May 27, 1980

Docket No. 50-348  
No. 50-364

Re.: Letter from Mr. A. Schwencer to  
Mr. F. L. Clayton Dated April 8, 1980,  
Concerning Auxiliary Feedwater

Enclosure 1

FIGURE 10

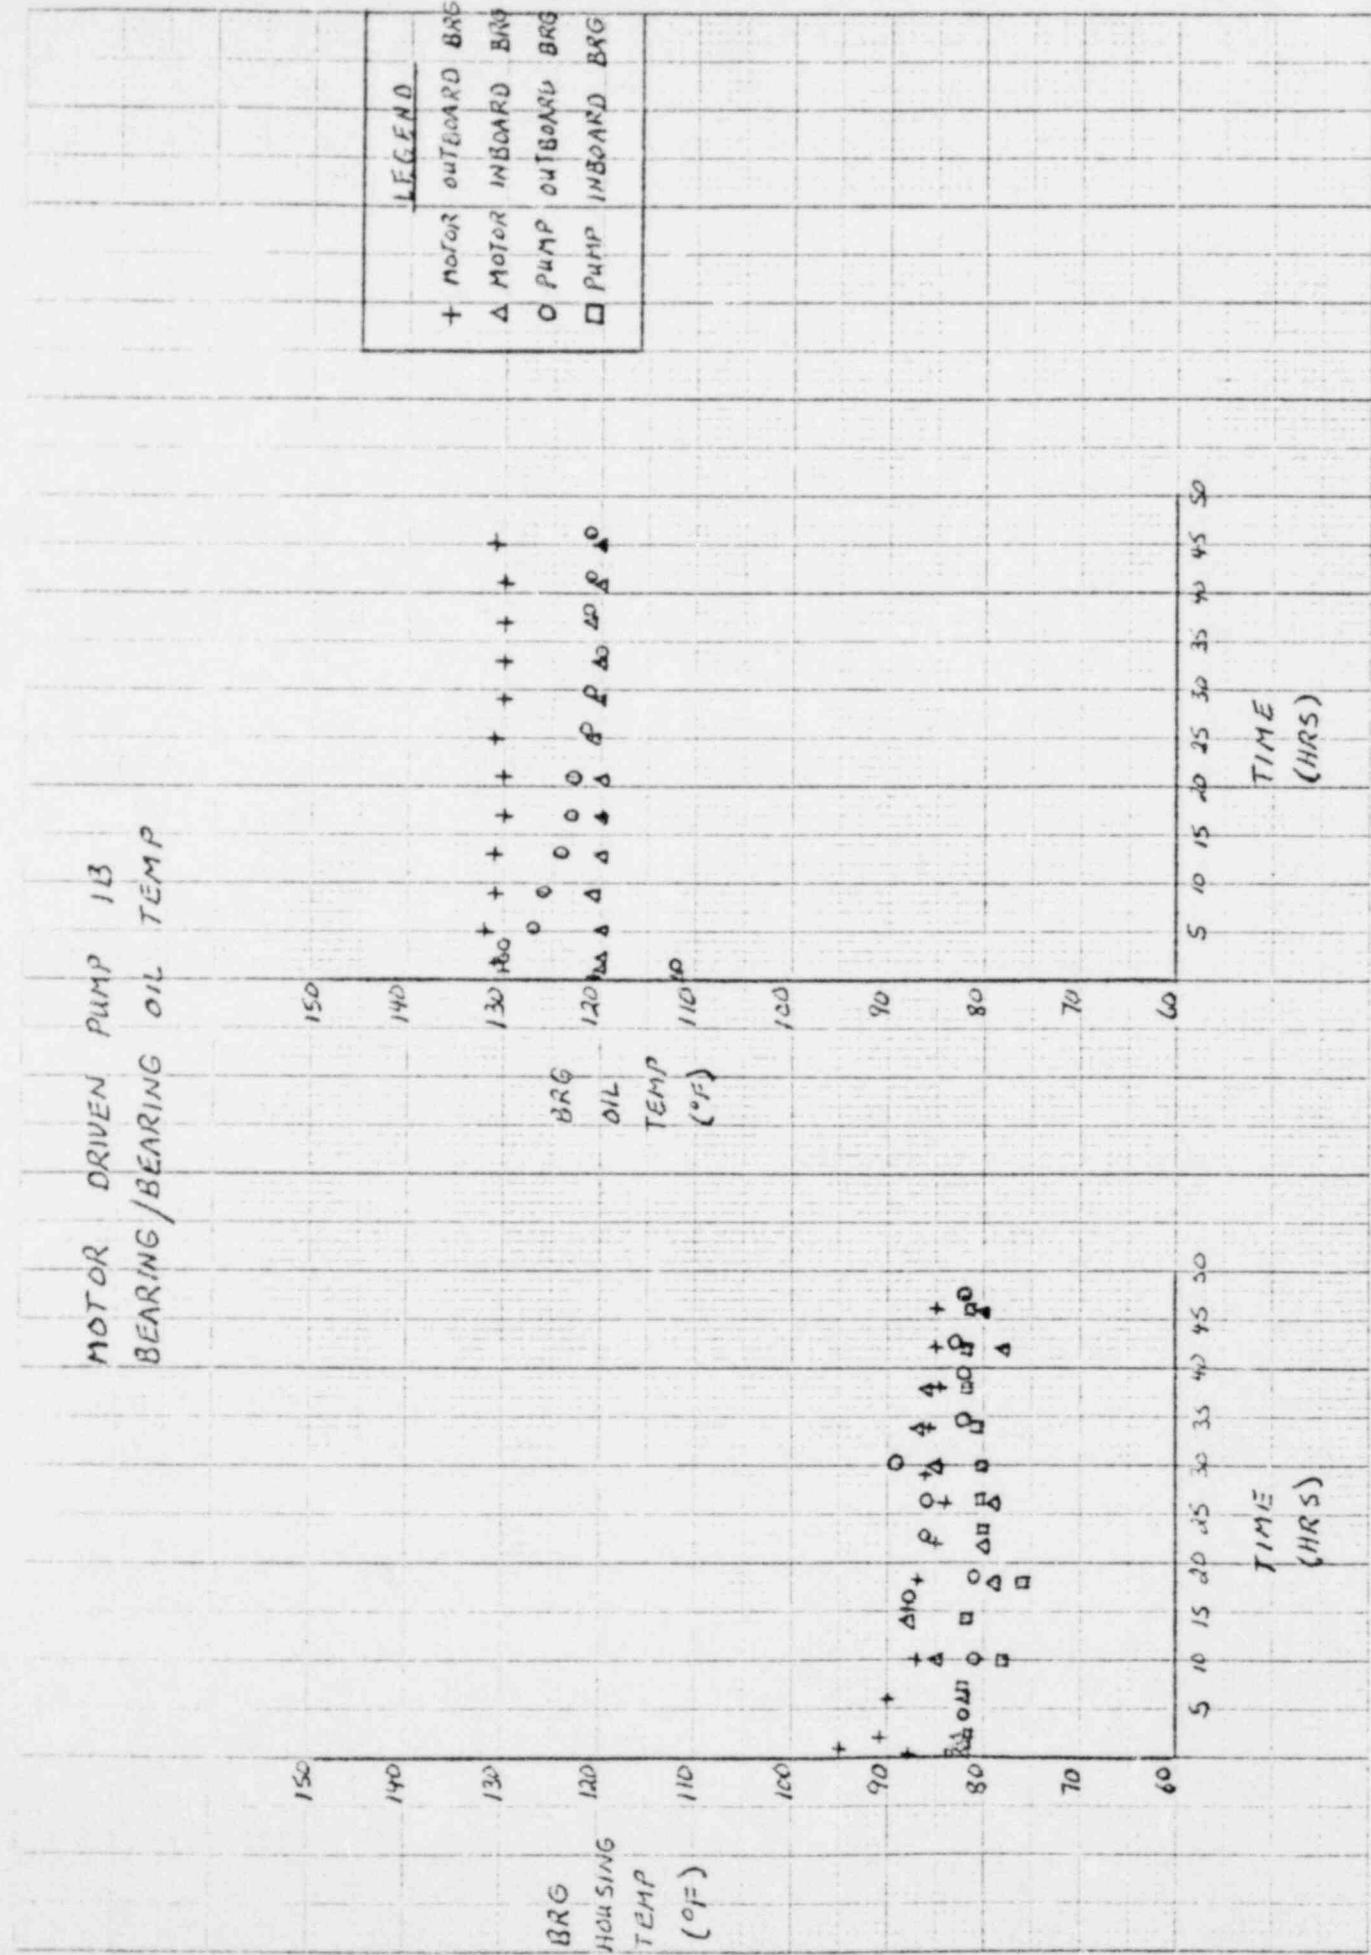
Plots of bearing/bearing oil temperature vs. time for each bearing of each AFW pump/driver demonstrating that temperature design limits were not exceeded.

The limit established for bearing/bearing oil temperature was 185° F. For both motor driven pumps, the bearing/bearing oil temperatures remained well below the limit as depicted in Figures 6 and 10.

FIGURE 11

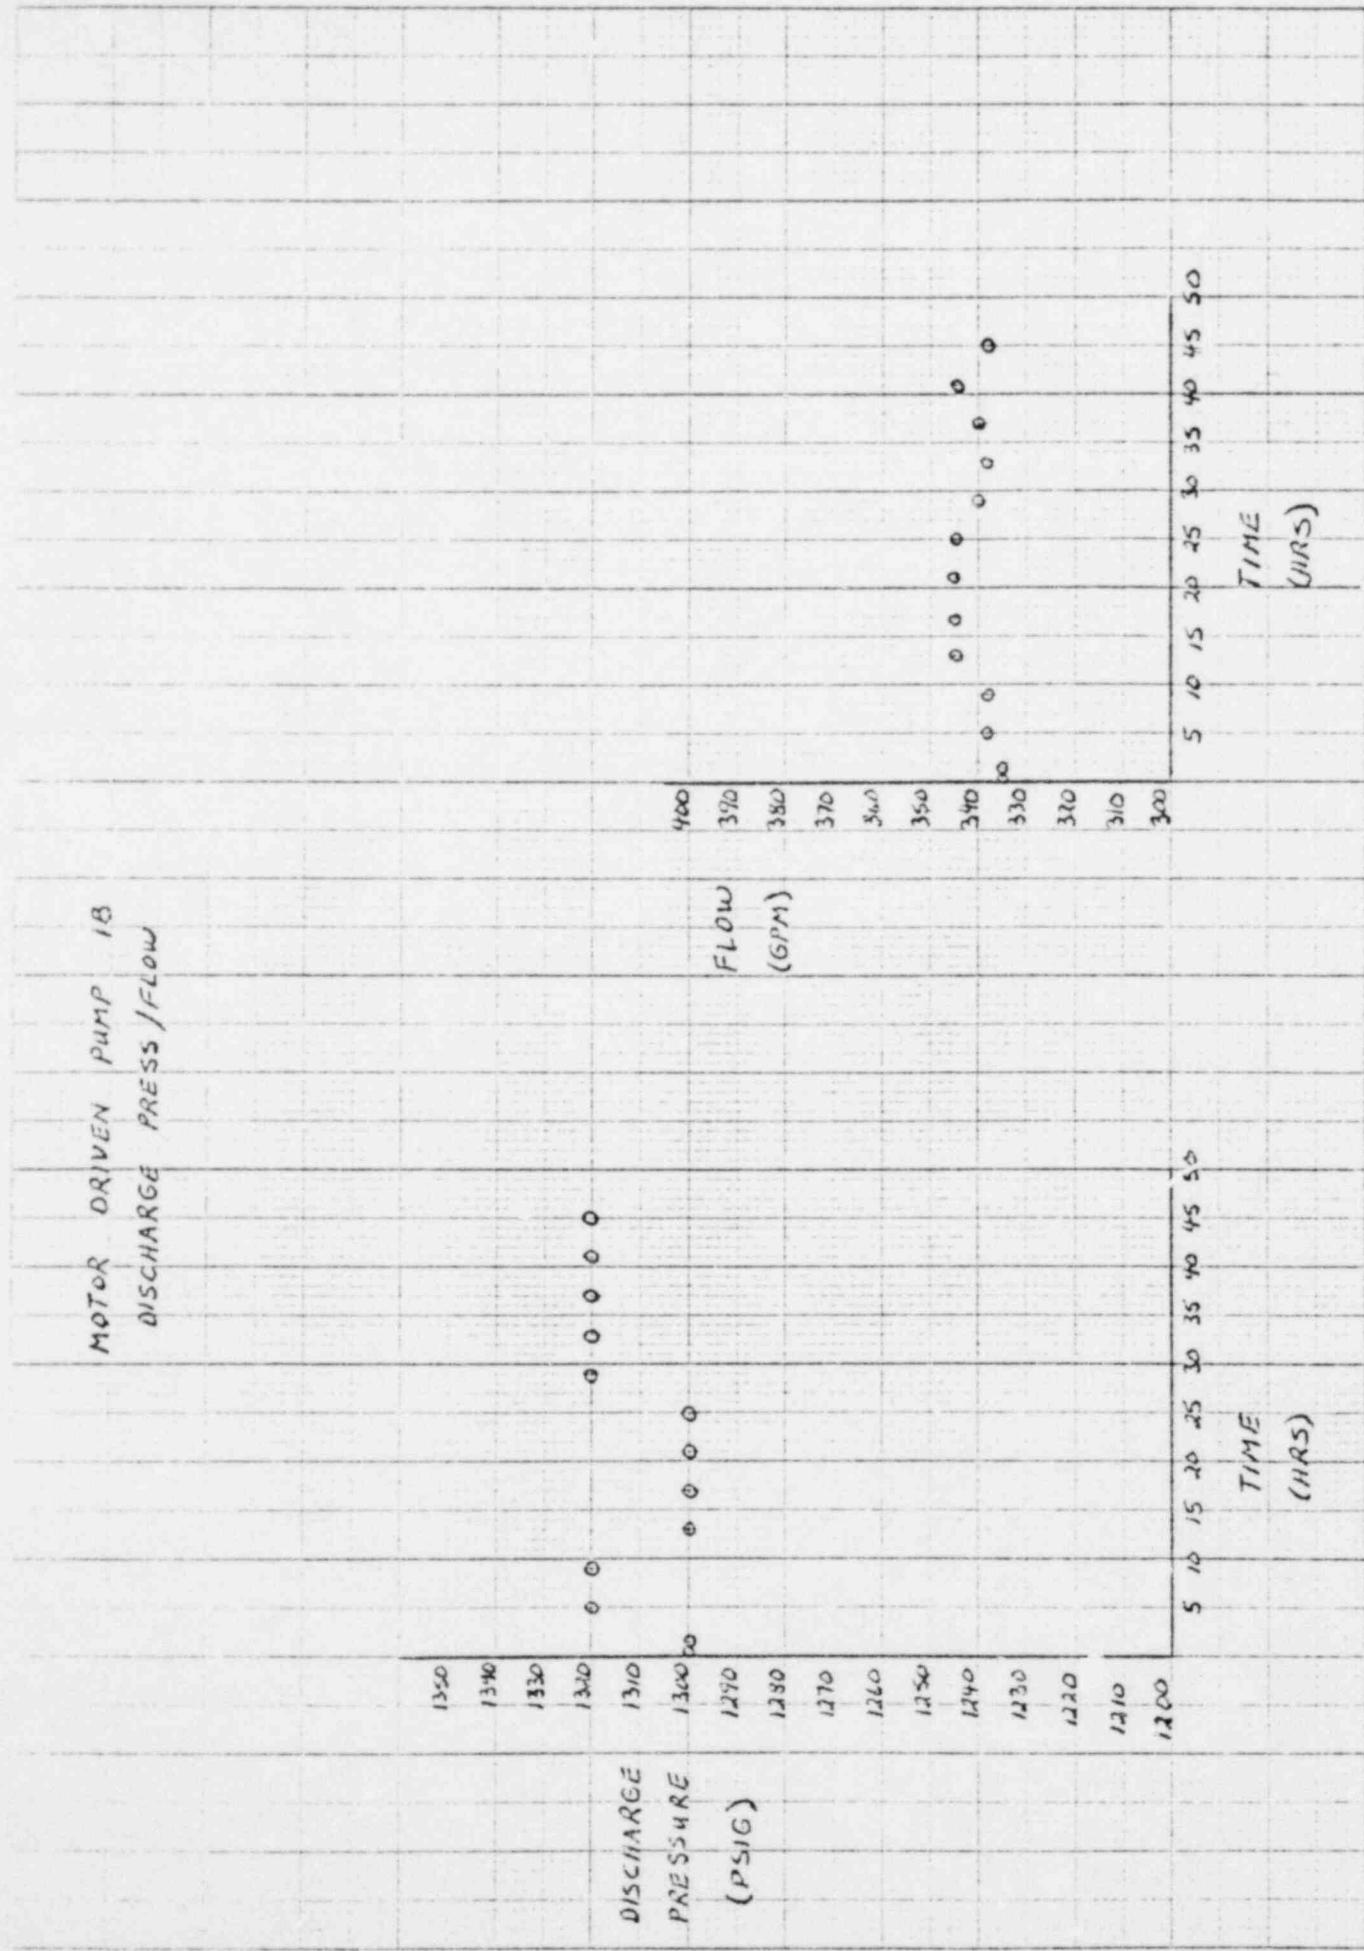
A discussion of how the test conditions (pump flow, head, speed and steam temperatures) compare to design operating conditions.

The pressure and flow for motor driven pumps 1A and 1B and the turbine driven pump are shown in Figures 7, 11 and 15 respectively. All readings are within the manufacturer's operating limits. The variation of pressure and flow with time on the TDAFW pump is attributable to drift of the flow control valve controllers, the turbine speed controller, or a combination of both. All pumps were operated at rated speed and since the tests on the turbine driven pump were conducted at 90% reactor power, steam temperatures were well above the 400°F. test requirement.

FIGURE 13

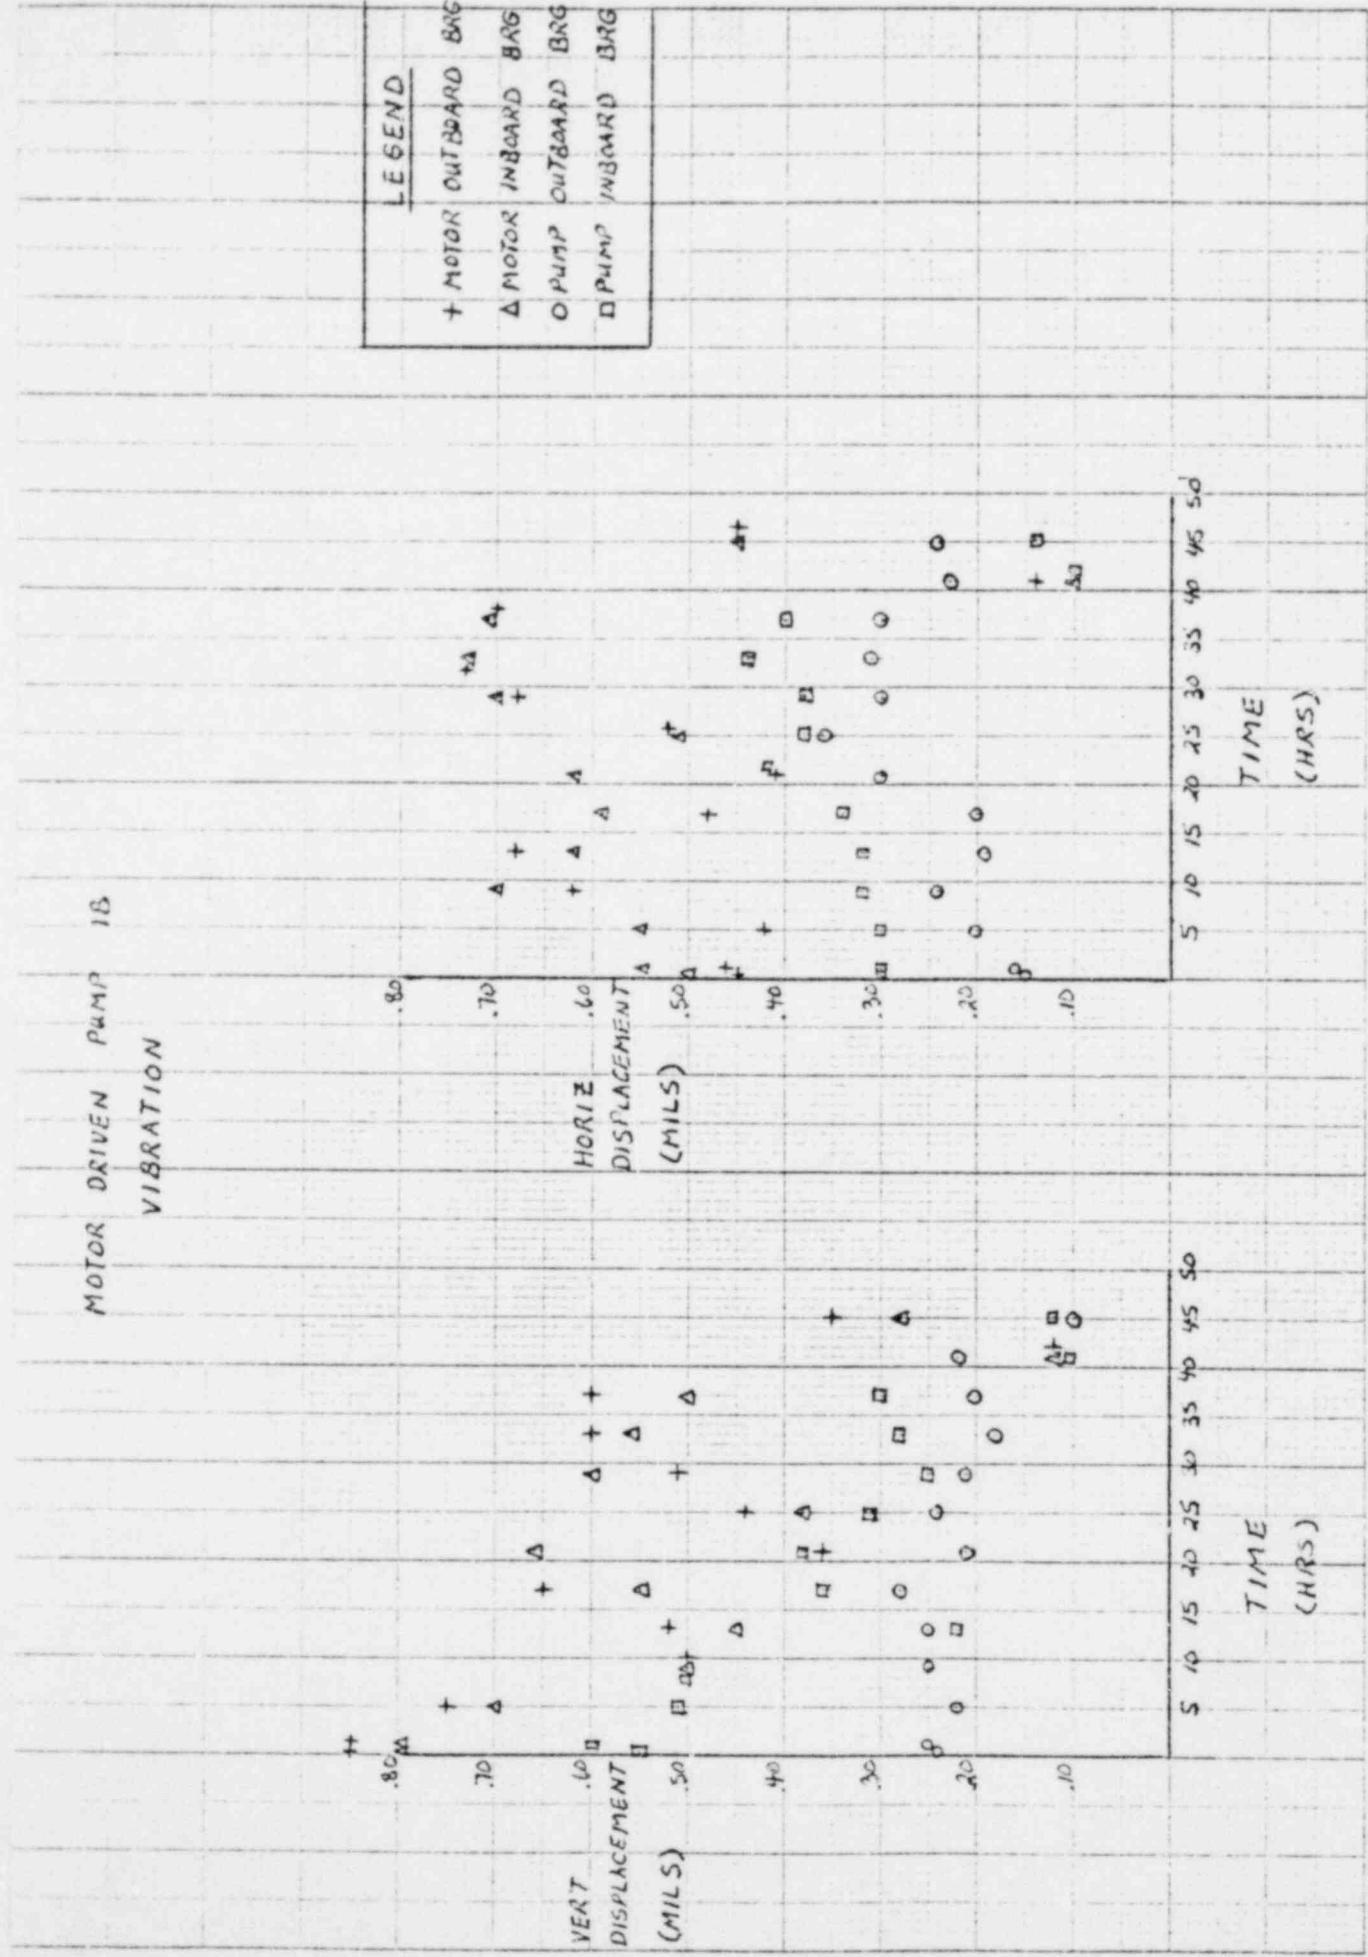
A statement confirming that the pump vibration did not exceed allowable limits during the tests.

Figures 9, 13 and 17 demonstrate that vibration in the motor driven and turbine driven pumps did not exceed allowable limits.
